MANDATORY SERVICE BULLETIN**NUMBER:** SB12-07**REVISION:** 00**DATE:** September 26, 2012**SUBJECT:** EXTERNAL CARGO COMPARTMENT JACK POINT REMOVAL**EFFECTIVITY:**

KODIAK 100 Series Aircraft Serial Numbers: 100-0001 thru 100-0072 with External Cargo Compartments.

TITLE: External Cargo Compartment Jack Point Removal
SERIAL RANGE: 100-0001 thru 100-0072

PAGE: 1 of 8
REPORT NO.: FSI-047
REVISION: 00

Figure 5-1: Optional External Cargo Compartment Modification

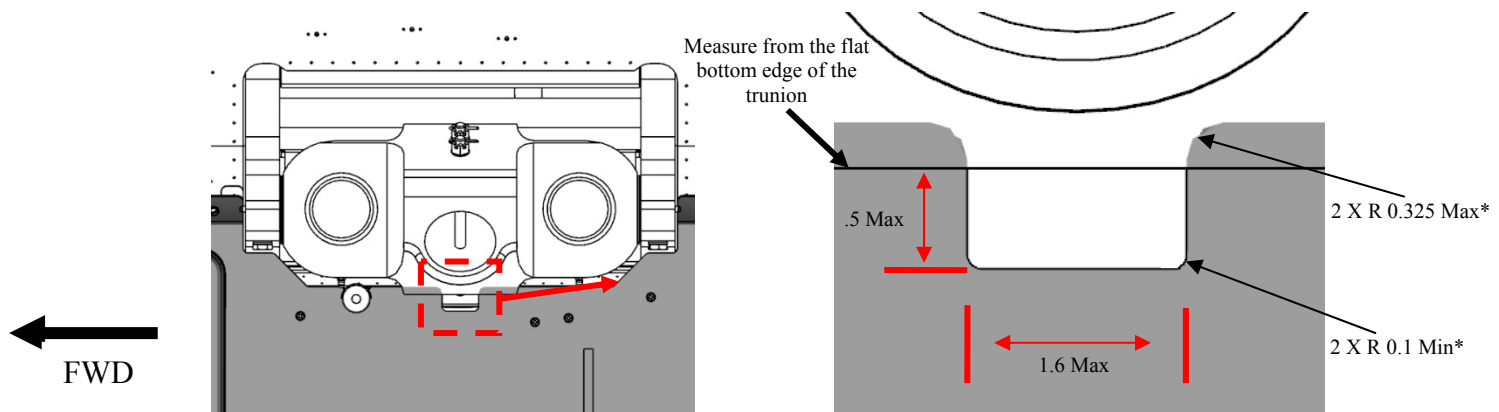
1. In order to remove the jack points, the material around the external cargo compartment may be removed up to the limits shown in Figure 5-1.
2. If it is not necessary to remove any material around external cargo compartment jack point openings, proceed to Section 5.2.

The modifications shown above illustrate the maximum allowable modifications limits. Remove only the amount of material needed to obtain access to remove the jack points.

Figure 5-2: Placard Installation

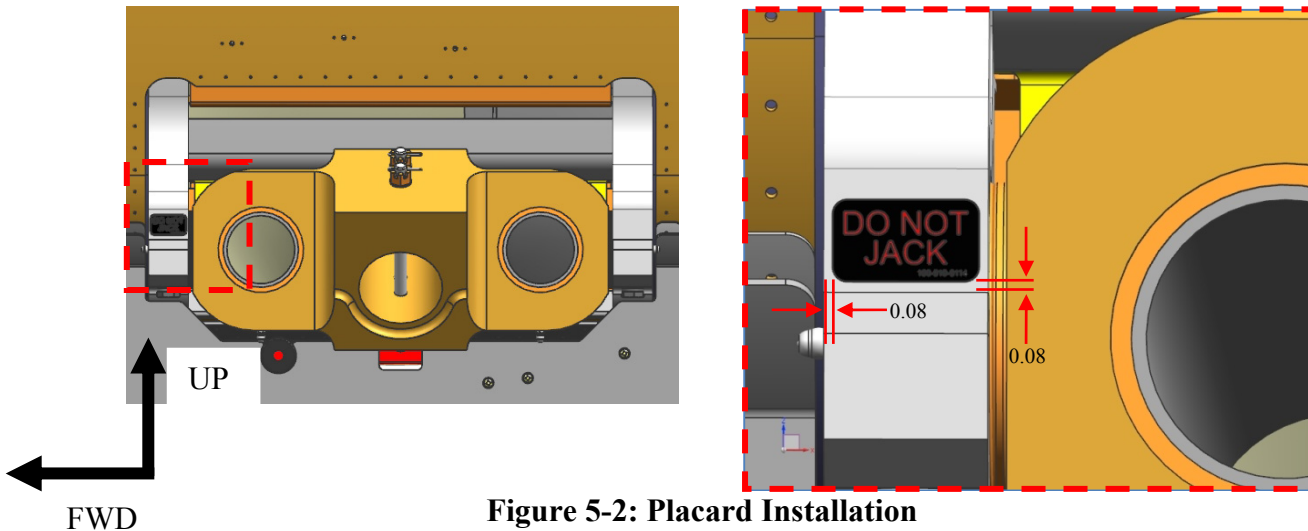
1. Remove the protective backing on the placard (P/N 100-910-0114) and position as shown in **Figure 5-3** on both sides of the aircraft.

Figure 5-3: Jack Point Mounting Location

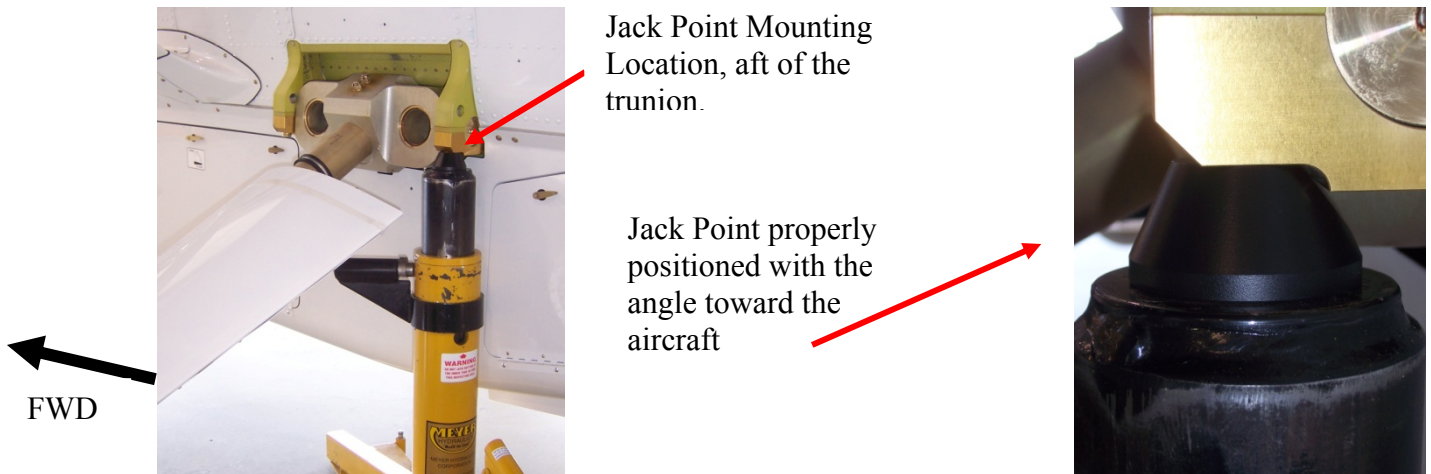
The jack point mounting location is designed to be located aft of the trunion. Lifting the aircraft with the jack point (P/N 100-420-1123) in any location other than that illustrated in **Figure 5-3** may cause damage to the aircraft, or possible injuries to maintenance personnel.

1. Remove the main landing gear fairings in accordance with the *KODIAK® 100 Maintenance Manual*, Chapter 32.
2. Position a jack point (P/N 100-420-1123) onto the head of a standard aircraft jack for each side of the main landing gear.

4. Raise the three (3) jacks until the jack points are correctly positioned under the jack point mounting locations shown in **Figure 5-3** and **Figure 5-4**.
5. Simultaneously raise all three (3) jacks, ensuring that the aircraft is level as the tires clear the ground.
6. Position the tail stand under the tail tie-down for additional security.

Figure 5-4: Forward Jack Point Location

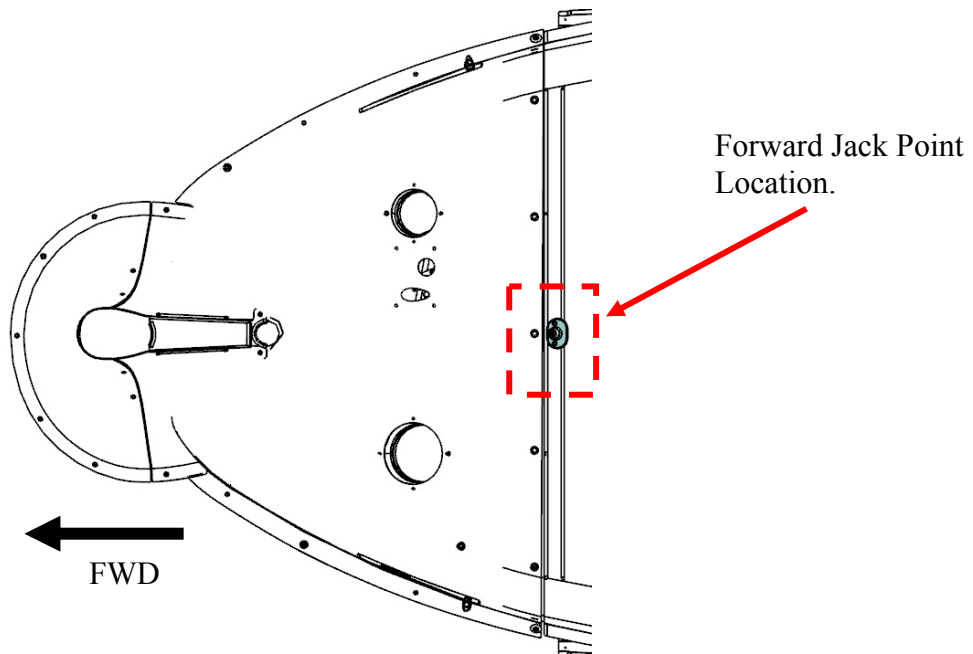
3. Position a jack under the forward pod jack point illustrated in **Figure 5-4**.
